AMENDMENTS TO THE DRAWINGS

Application No.: 10/717,974

Amdt. dated March 3, 2006

FIG. 5

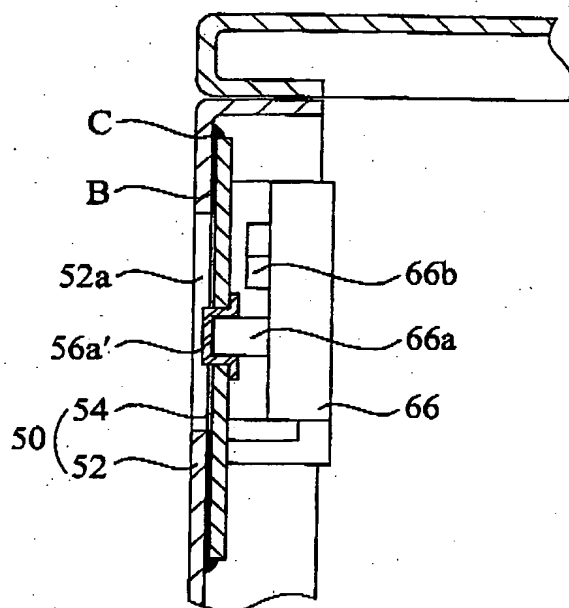
With respect to Fig. 5, the reference label “ **56a’** ” has been amended to “ **66a’** ”.

With respect to Fig. 6, the reference line associated with “ **66a’** ” has been corrected. In addition, the reference line associated with “ **54h** ” has been corrected.

As an initial matter, the Examiner objected to the drawings and asserted that the proposed reference corrections may not be accurate because Figure 5 and Figure 6 refer to controls **66a** and display **66b**, which are depicted at different elevations in Figure 5 than in Figure 6.

Applicants respectfully request withdrawal of the objection to the drawings. More specifically, Applicants have amended the drawings, particularly the reference line associated with reference label **66a'**. Accordingly, favorable consideration and approval of the drawings is respectfully requested.
